**PLANNING APPROVAL,  
PLANNED UNIT DEVELOPMENT &  
SUBDIVISION STAFF REPORT****Date: August 4, 2016**

<b><u>NAME</u></b>	Emogene Street Subdivision
<b><u>SUBDIVISION NAME</u></b>	Emogene Street Subdivision
<b><u>LOCATION</u></b>	2617 Dauphin Street (Southeast corner of Dauphin Street and the CSX Railroad Right-of-Way)
<b><u>CITY COUNCIL DISTRICT</u></b>	District 1
<b><u>PRESENT ZONING</u></b>	B-3, Community Business District.
<b><u>AREA OF PROPERTY</u></b>	2 Lots / 2.0± Acres
<b><u>CONTEMPLATED USE</u></b>	Planning Approval to allow a cell tower in a B-3, Community Business District; Planned Unit Development approval to allow shared access between two building sites; and Subdivision approval to create two legal lots of record from an existing legal lot of record.
<b><u>TIME SCHEDULE FOR DEVELOPMENT</u></b>	None given.

# DETAIL SITE PLAN

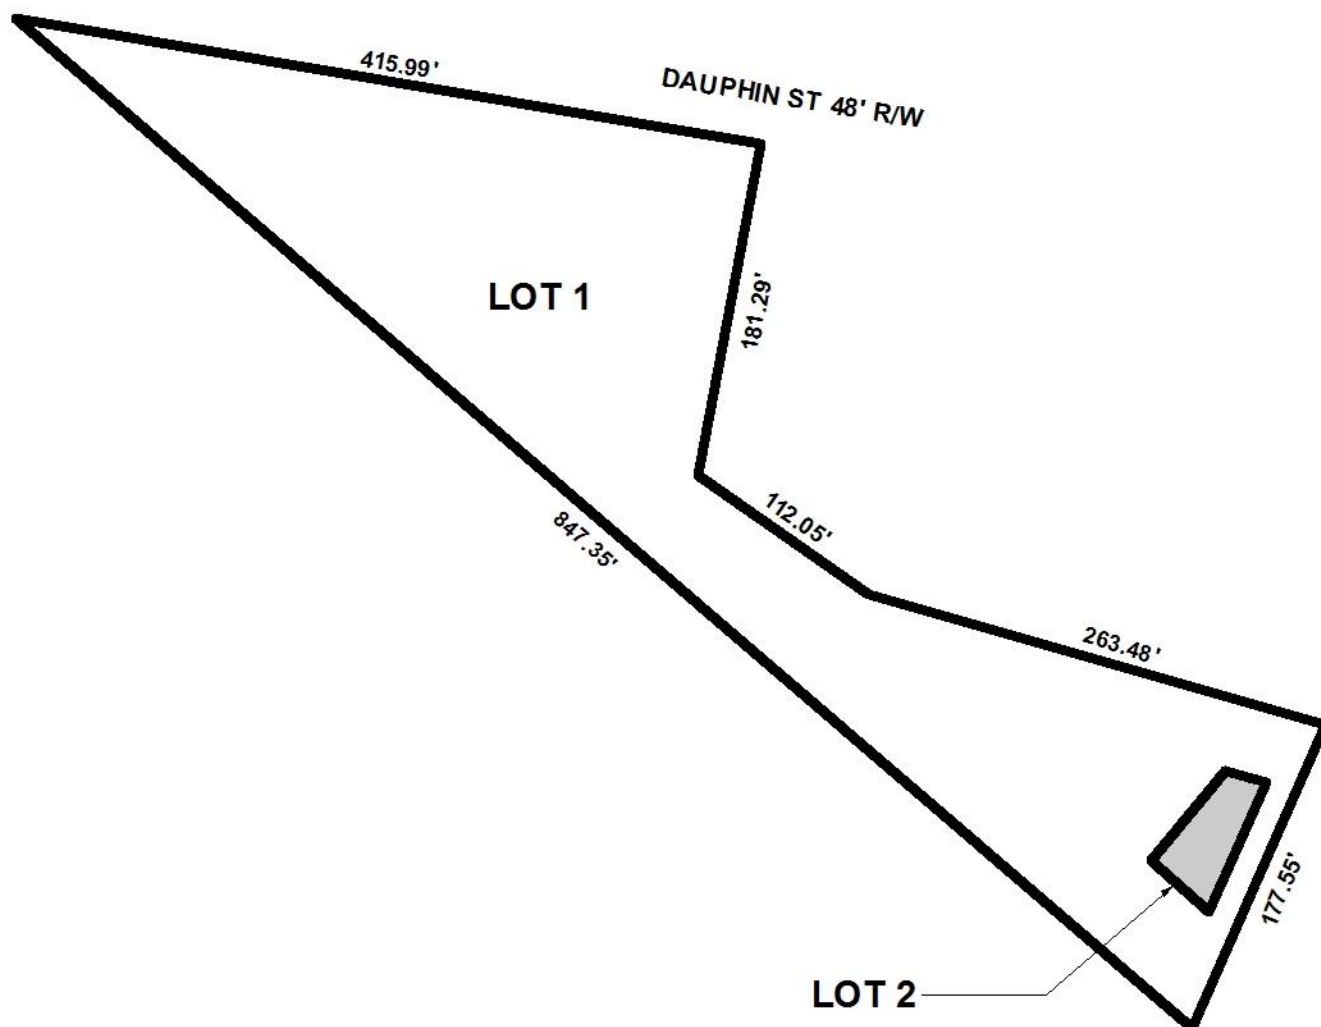
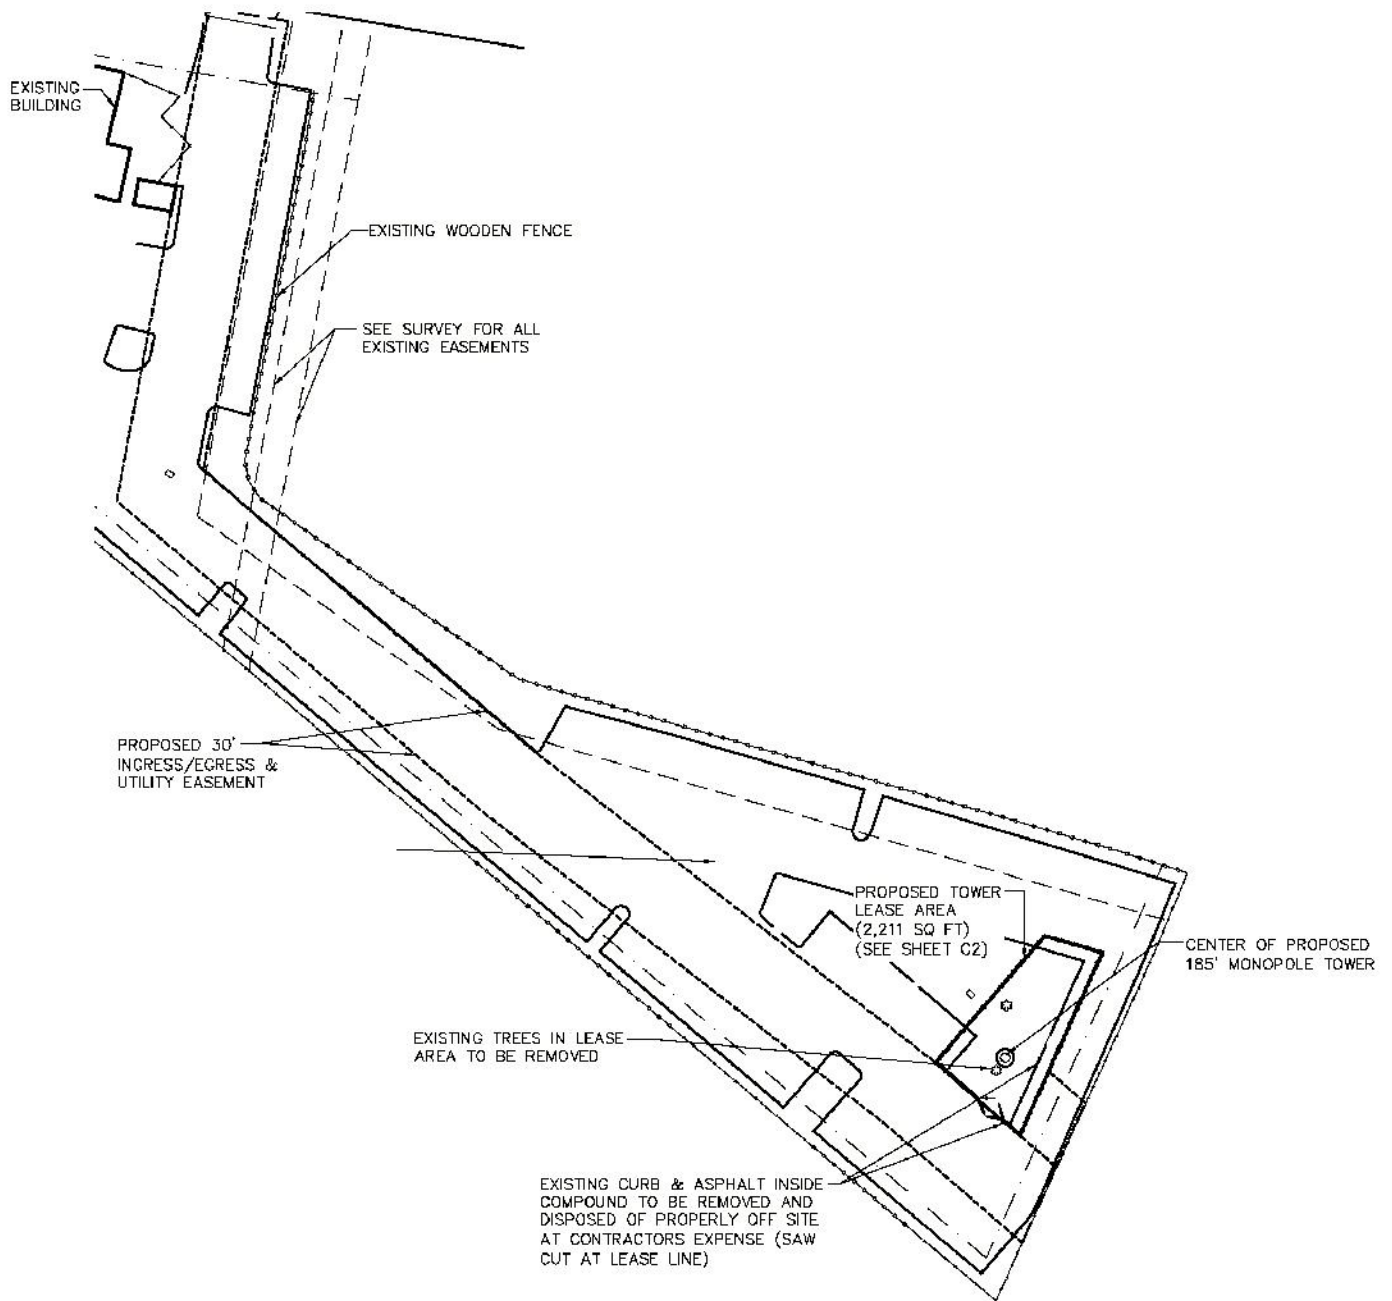
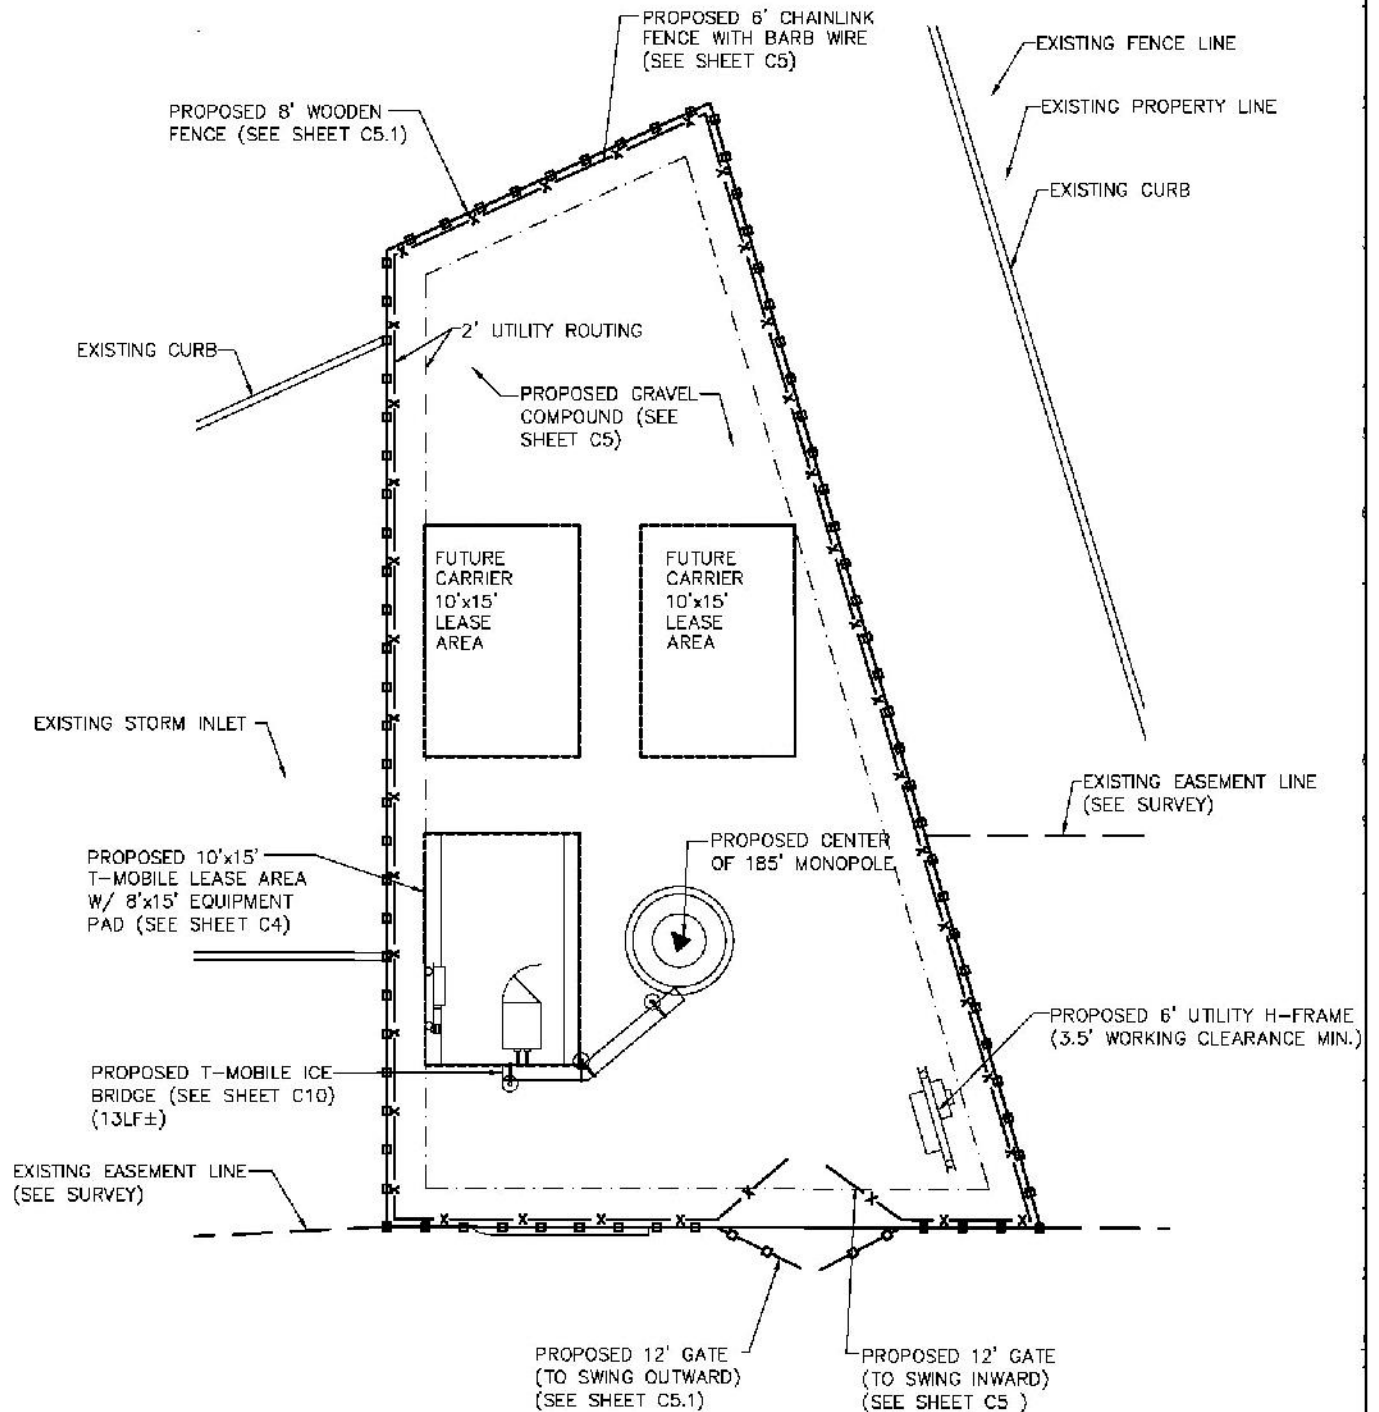
As access to the tower compound/lease parcel would be across the restaurant parking lot, a PUD is required to allow such shared access. The site plan indicates the tower compound proposed to be in the Southeast portion of the parking lot. The location would require the removal of one parking space and the restriction of access to possibly five or six other spaces, as well as the limitation of traffic flow to one-way within that area of the parking lot. However, as that area is far-removed from the main parking area close to the restaurant and as the site has at least twice the number of required parking spaces, the loss of these parking spaces would have negligible impact on the parking. As the tower lease parcel is proposed to be a separate legal lot of record and land-locked, its access would be via 30' easement for ingress and egress.

The site plan indicates an 8' high wooden privacy fence is proposed around the tower compound/lease parcel with a chain link fence topped with barbed wire just inside the compound from it. However, email correspondence from the applicant indicates the chain link and barbed wire fence will not be installed. Therefore, the site plan should be revised to remove the chain

link/barbed wire fence. The site plan does not indicate any landscaping within the compound or tree plantings around the compound. Should the Board of Zoning Adjustment deny the requests for Landscaping and/or Tree Planting Variances, the site plan should be revised to indicate compliant landscaping and/or tree plantings. However, as the site is located within a commercial site developed according to the tree planting requirements of the Zoning Ordinance, and as two existing required trees are proposed to be removed, their removal will require a tree removal permit, and should be coordinated with Urban Forestry.

- 1) revision of the site plan to remove the chain link/barbed wire fence within the tower compound;
- 2) revision of the site plan to provide compliant landscaping and/or tree plantings, to be coordinated with Urban Forestry, in the event the Board of Zoning Adjustment denies the landscaping and/or Tree Planting Variance requests;

- 3) obtaining of tree removal permits for the two trees within the compound area proposed to be removed, to be coordinated with Urban Forestry;
- 4) revision of the site plan to identify each lot and label each with its size in both square feet and acres, or the furnishing of a table on the site plan providing the same information;

MONOPOLE TOWER ELEVATION

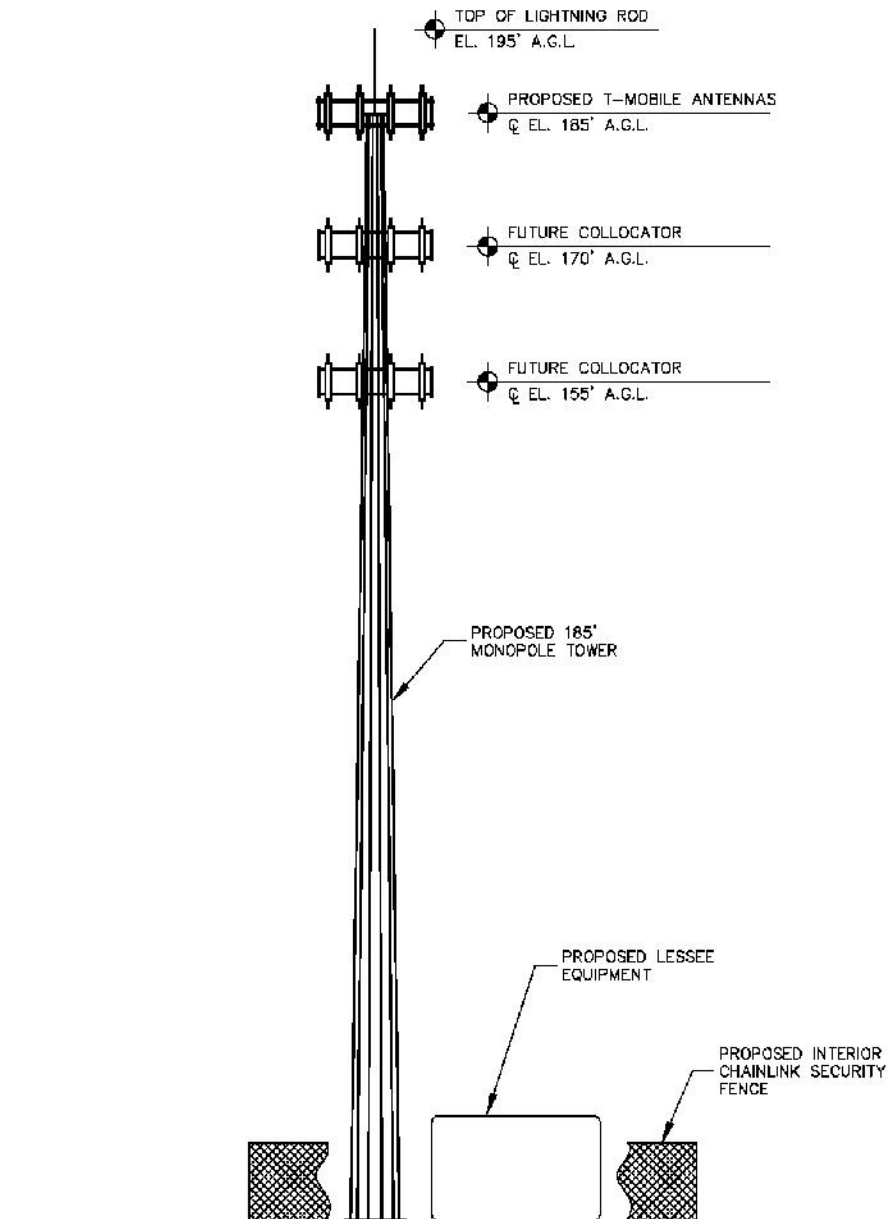
The tower elevation drawing in the application indicates the actual tower height to be 185' but with the antennas extending to an unspecified height above that. The Telecommunications towers and facilities section of the Zoning Ordinance specifies that tower height is determined by the height of the tower structure itself, the base pad, and any other telecommunications facilities attached thereto, and measured from grade. Therefore, as the height proposed is 185', the proposed antennas should be lowered so that no portion thereof extends above the 185' top-of-tower structure elevation. Should the Height Variance be modified by the Board of Zoning Adjustment to a different height, the tower elevation drawing should be revised accordingly.

- 1) the tower limited to a monopole design;
- 2) revision of the tower elevation drawing so that no portion of the antennas project above the 185' tower structure height, or whatever height may be approved by the Board of Zoning Adjustment;
- 3) revision of the site plan to remove the chain link/barbed wire fence within the tower compound;
